Norwich to Tilbury

**Document: 8.5.3 Applicant's Written Summary of Oral Submission
and Response to Action Points for Issue Specific Hearing 1**

Planning Inspectorate Reference: EN020027

Figure C.1 Illustrative Cross Section of a High Voltage Direct Current Working Width

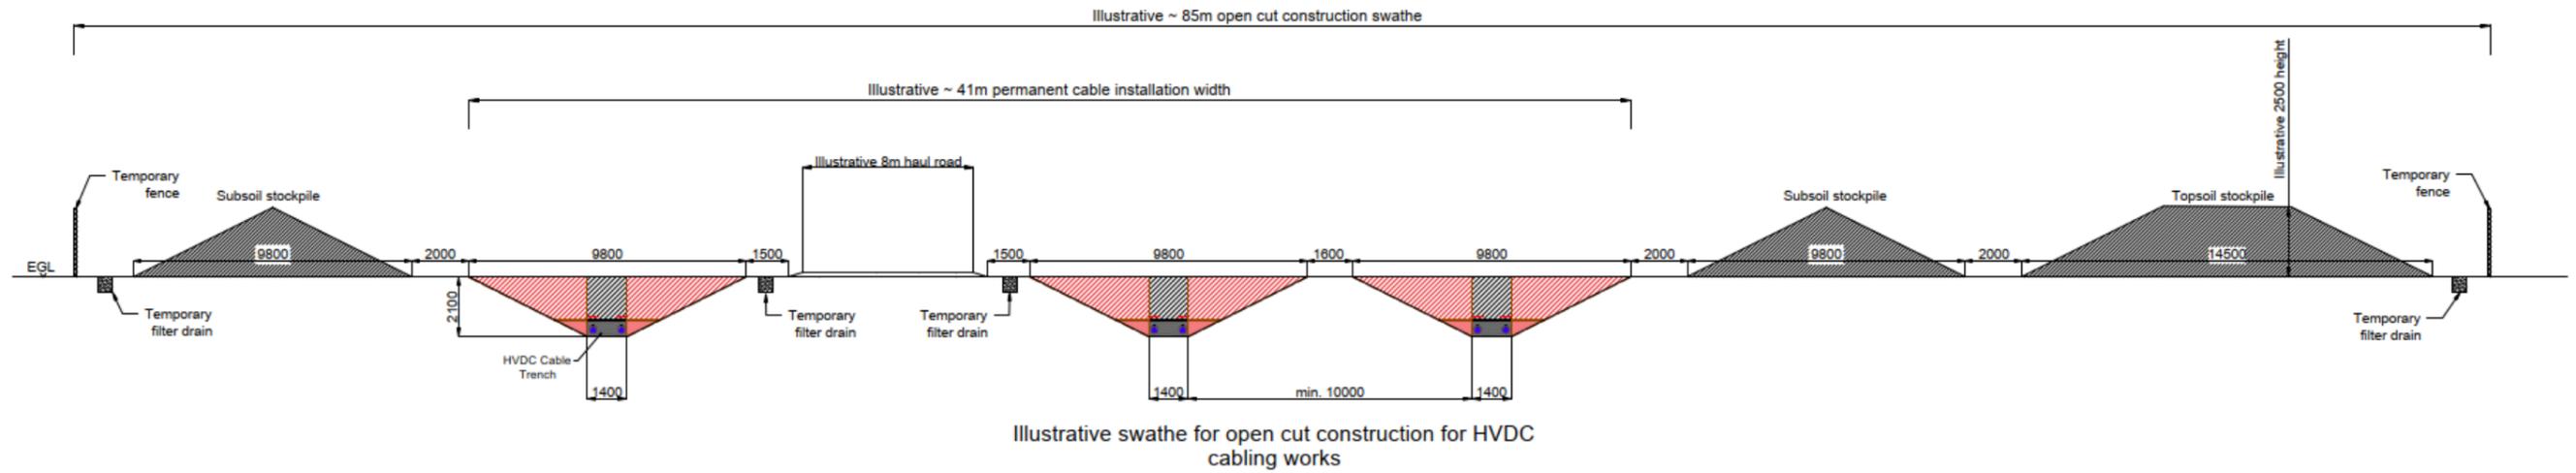
Ardleigh and Little Bromley Parish Council	Can the Applicant provide a slide showing the trenching requirements of DC cables for comparison with the AC cables slide?	<p>A comparable cross section for high voltage direct current (HVDC) was not provided in the submission as this form of cable is not proposed for the Project. An illustrative cross section is provided in Annex C1. This illustrates the likely arrangement given increased separation between sets of cables.</p>

Action No.	ExA Description	Applicant's Response
		<p>remaining trench on the other side. This would create an overall cable swathe of around 41 m in an 85 m construction swathe (refer to the figure in Annex C) compared with the indicative 50 m cable swathe for alternating current (AC) installation within a 120 m construction swathe.</p> <p>Standard practices for installation are based on two trenches being excavated at any one time, working on the two outer trenches and then in towards the middle trenches. This would be the same with the three trenches required for a HVDC connection.</p> <p>The Applicant would note that the effects from three converter stations to either side of the Dedham Vale National Landscape and the additional costs do not make the use of HVDC through the Dedham Vale National Landscape a viable basis for the Project to be taken forwards.</p>
Pylons East Anglia Ltd	Was there a consideration of undersea cabling making landfall at Bradwell-on-Sea? What Bradwell-related alternatives were considered, having regard to potential usability of existing infrastructure?	<p>In respect of alternatives to route via the old Bradwell power station, the Applicant has considered this as a connection point for the customers and as a waypoint for the connection between Norwich and Tilbury (in onshore and partially offshore connections). In all cases the onward connection assumes use of an existing overhead line connection to the Bradwell B site. This has been operating at lower voltage (132 kV) and has not been used for a few years and is in generally poor condition. This overhead line would need to be rebuilt but also interacts with a Special Protection Area; however, any rebuild to make this onward connection via Rayleigh to Tilbury is also constrained by urban development and further designations and some sections may need to be re-routed. All variants are considered less preferred through various combinations including additional interface with environmental designations, very constrained corridor for a connection to Tilbury, additional infrastructure requirement over and above the core Project or where the alternatives were not taken forwards due to being less economical and efficient. See also 5.1 - 2025 Consultation Report [APP-066] - response code 9-2.756 and 7.20 - 2023 Design Development Report [APP-358] - section 5.5.2-5.2.4.</p>

Figure C.2 Illustrative Cross Section of a UK Power Networks High Voltage Alternating Current Working Width

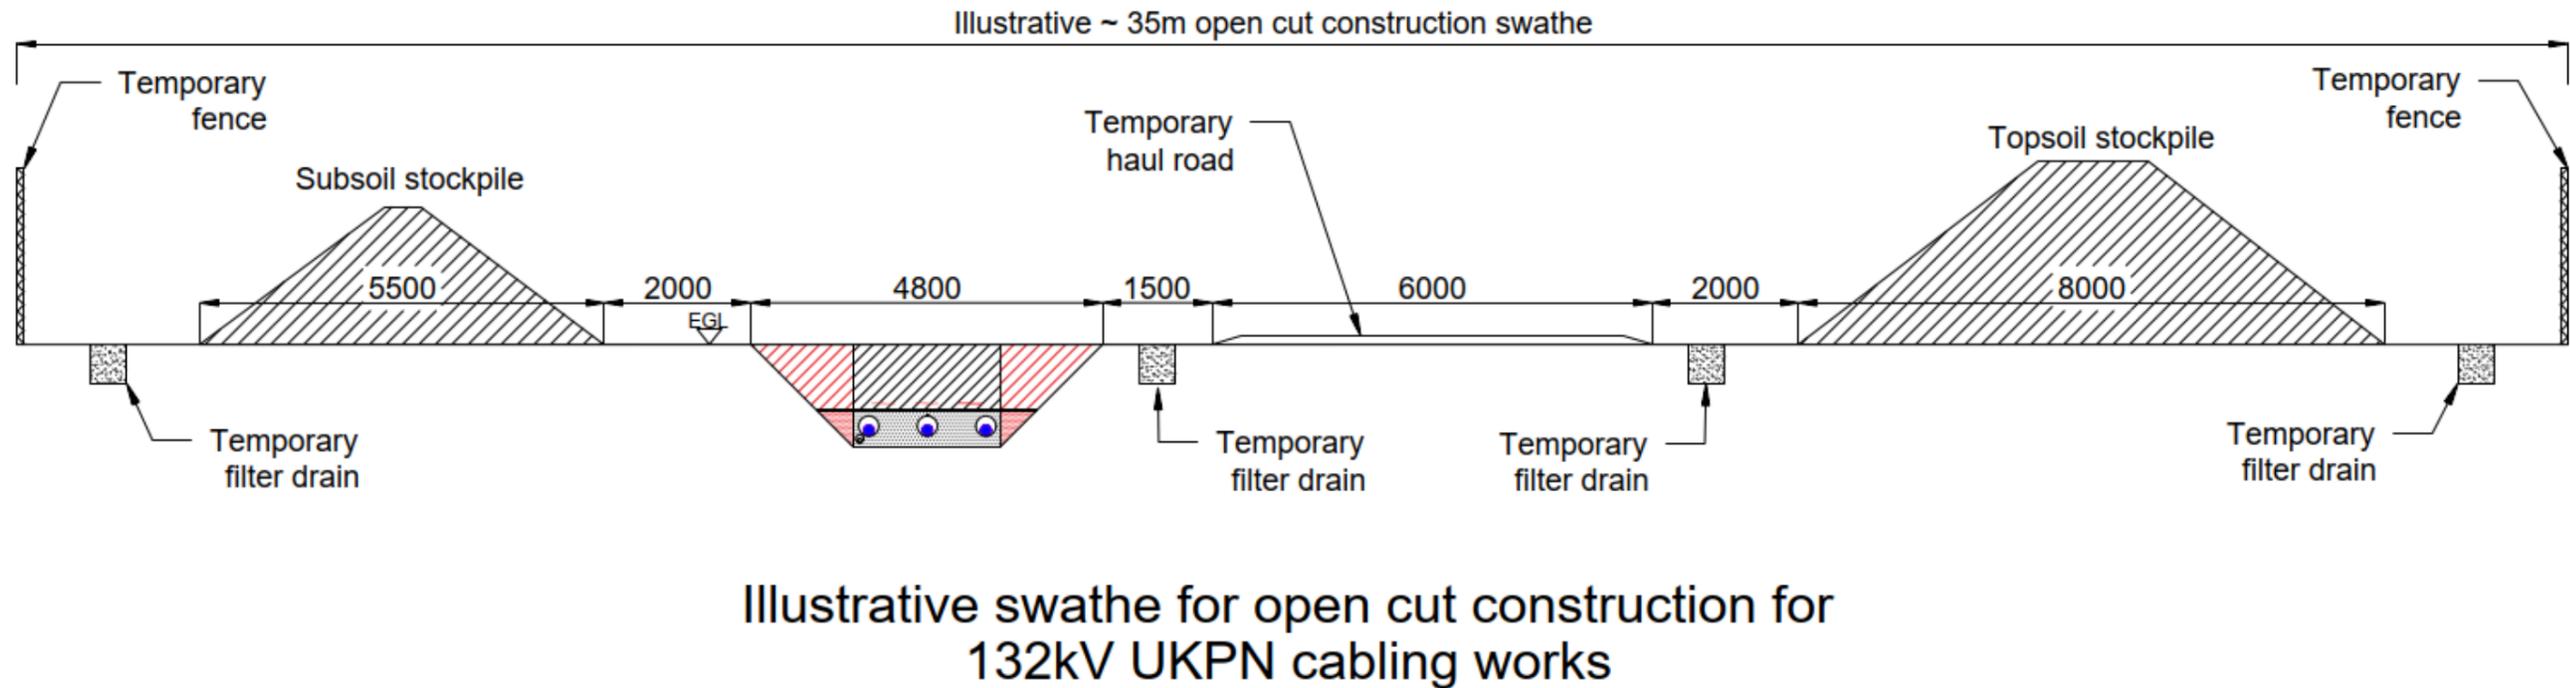
4b	Explain the differences between the limits of deviation between 400kV undergrounding and 132kV undergrounding with use of cross sectional drawings.	<p>The LoD allow for adjustment to the final positioning of the permanent features, for example to avoid localised constraints or unknown or unforeseeable issues that may arise. The key difference between the applied LoD of the 400 kV underground cables and the 132 kV underground cables is related to the smaller scale of the 132 kV assets. This can be seen on the illustrative cross section in Annex C2.</p> <p>Table 4.3 of 6.4 Environmental Statement Chapter 4 - Project Description [APP-130] provides details of the Order Limits and LoD for the Project, including the proposed 400 kV underground cables and the removal of existing and proposed underground cable diversion of 132 kV overhead lines.</p> <p>Paragraphs 4.8.65 to 4.8.78 of 6.4 Environmental Statement Chapter 4 - Project Description [APP-130] describe the works associated with the 400 kV underground cables.</p> <p>Paragraphs 4.8.90 to 4.8.98 of 6.4 Environmental Statement Chapter 4 - Project Description [APP-130] describe works associated with UK Power Networks 132 kV pylons, including works to remove, underground and divert.</p> <p>As stated in 6.4 Environmental Statement Chapter 4 - Project Description [APP-130], paragraph 4.8.66, the 400 kV underground cable 120 m construction corridor</p>

Action No.	ExA Description	Applicant's Response
		<p>includes typically six cable trenches for 18 cables (three cables per phase). Comparatively, in paragraph 4.8.96, the installation of the 132 kV underground cable diversions is assumed to be in a single trench typically up to 3 m in width.</p>
4c	<p>Clarify the width and depth of the trenches with reference to and provision of the cross sections as displayed at the hearing.</p>	<p>Each trench is excavated to 1.4 m depth with a base width of 2 m (giving a trench width at ground level of around 4.8 m assuming a stable soil slope). This is shown on 2.6.1 Design and Layout Plans - Subs and Cables [APP-041], AENC-MMAC-ENG-DWG-0085-01 (Illustrative high voltage cable direct buried cross section and construction easement drawing). Further description of the installation methodology is provided in paragraphs 4.8.65 to 4.8.78 of 6.4 Environmental Statement Chapter 4 - Project Description [APP-130].</p> <p>The widths and depths are demonstrated in 2.6.1 Design and Layout Plans - Subs and Cables [APP-041], AENC-MMAC-ENG-DWG-0085-01. The typical depth of the trenches is 0.9 m to the top of the cable protection tiles and 1.4 m to the bottom of the trench.</p> <p>Each trench is suitably spaced apart to allow for the required heat dissipation between cables and circuit phases. For each circuit as shown in 2.6.1 Design and Layout Plans - Subs and Cables [APP-041], AENC-MMAC-ENG-DWG-0085-01, this is depicted as typically 2.2 m from the top of the trenches and 5 m from the bottom.</p>
